# PREVOST

## WARRANTY BULLETIN

WB12-31B

DATE : NOVEMBER 2012	SECTION : 01 - Engine
EXPIRATION: NOVEMBER 2014	
SUBJECT : DIPSTICK REPLACEMENT- D13 US07 AND US10

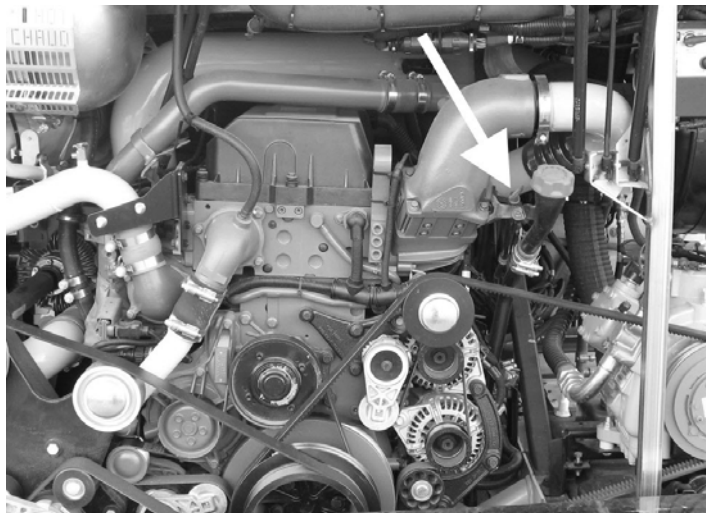
On the vehicles affected by this bulletin, a new and improved dipstick is available for installation.

*US07 engines*, order kit 012809 which includes:

*US10 engines*, order kit 012810 which includes:

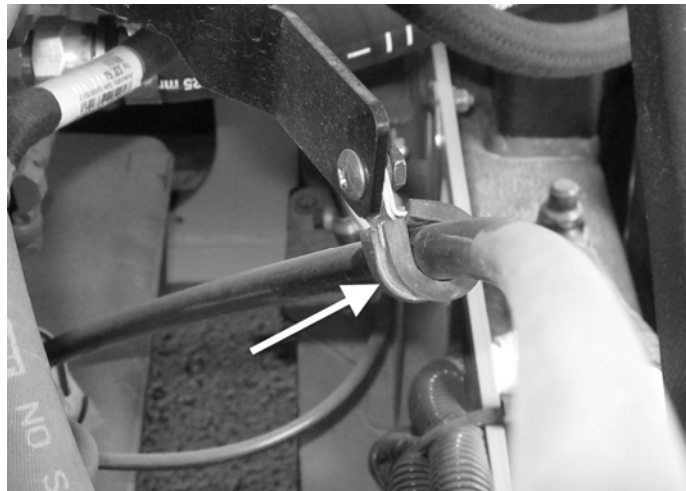
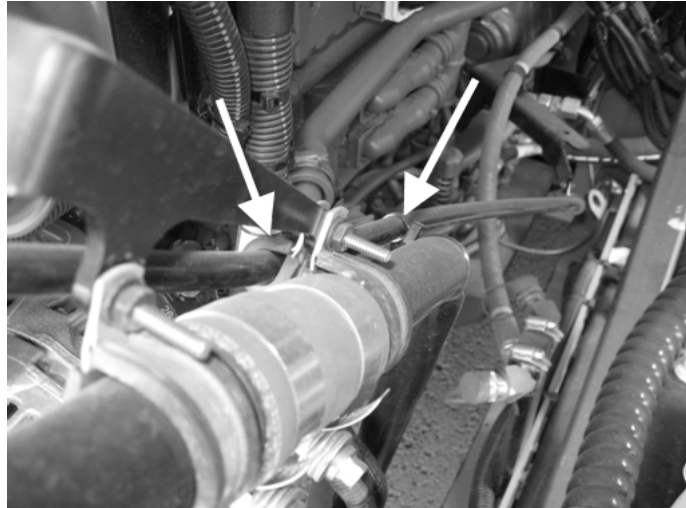
1. Locate the dipstick on the Engine

2. Start by removing this screw.  
Reserve hardware for re-install

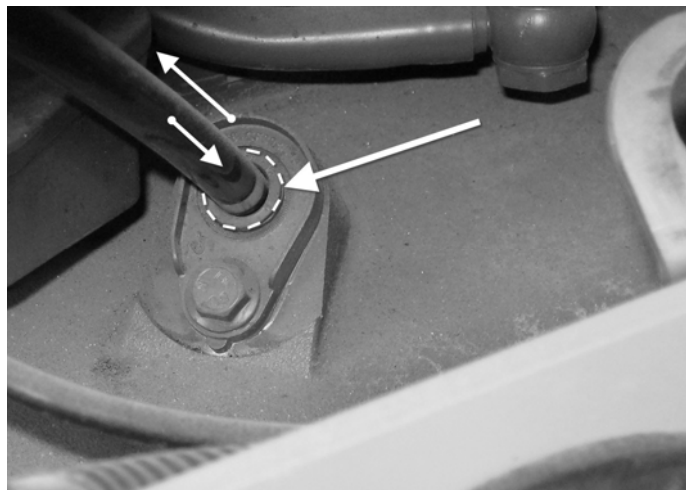
4. At the oil pan, depress ring.

Push tube in a jerk motion and then pull to release.

*Movement to release tube is similar to disconnecting a pneumatic quick coupling connection.*

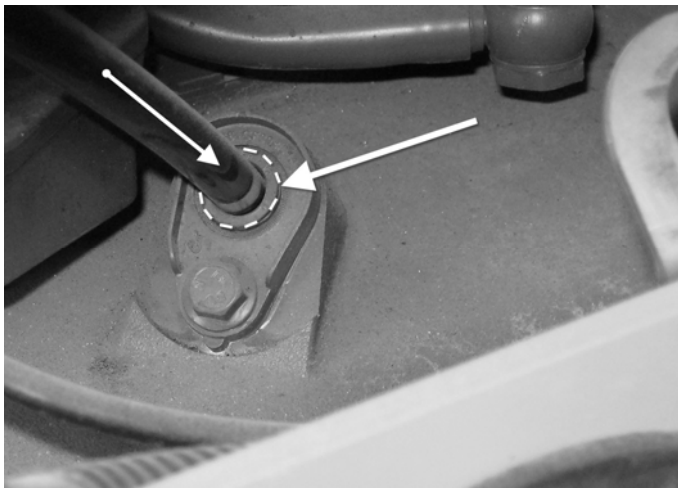
1. Insert new dipstick tube fully in oil pan coupling.

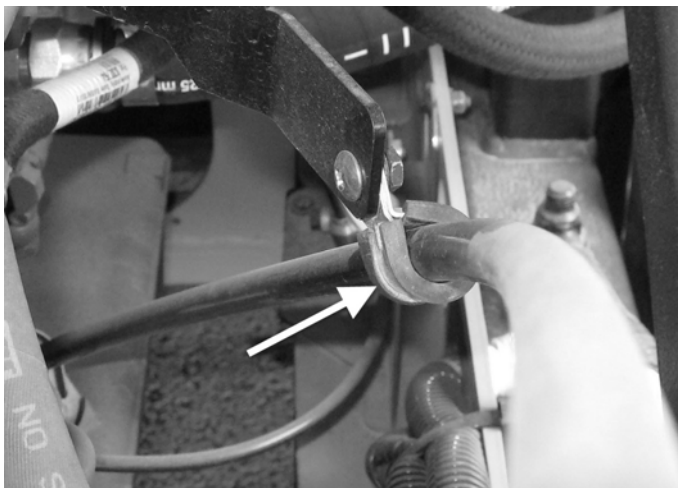
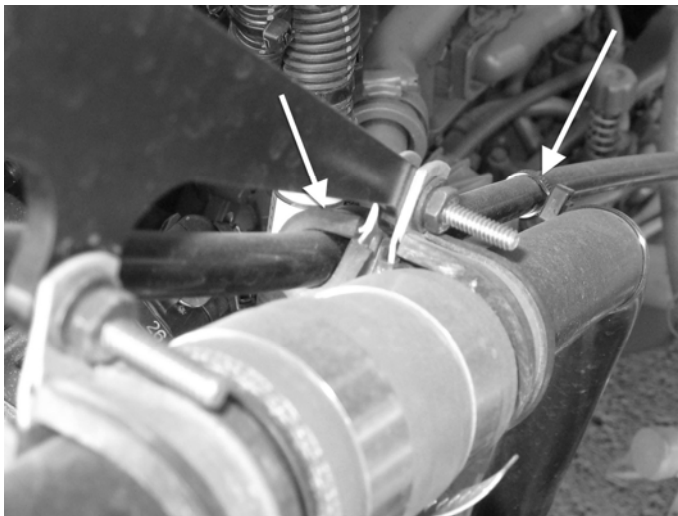
2. Secure the dipstick tube reusing the clamps and hardware removed earlier. Replace any part not suitable for re-install.

3. Install double loop nylon tie #507664.

4. Use reserved screw to secure handle end of new dipstick tube.

Hand tighten hardware.

Lightly hand tighten screw to allow adjustment in following steps.

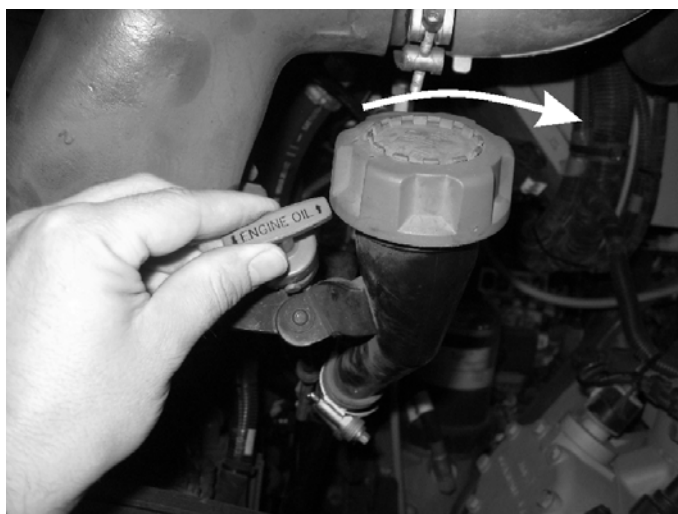
5. Fill tube will need to be rotated slightly away from new dipstick handle.

6. Slack tube collar and clamp at the flexible connection.

*The flexible connection tends to stick to the fill tube. Gently insert a flat screwdriver to release and allow rotation of the fill tube.*

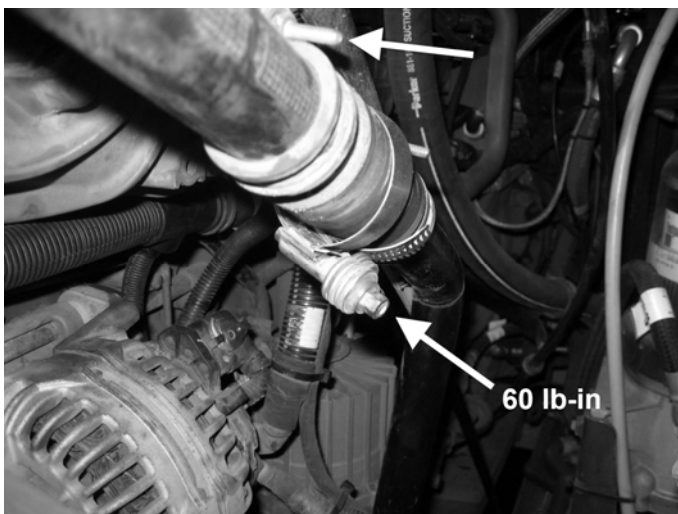
7. Rotate fill tube to this suggested position.

Ensure fill tube stays in position even if clamps are loose.

8. Make sure there is no remaining tension on the fill tube before tightening the collar and clamp.

Tighten collar to 60 lb-in
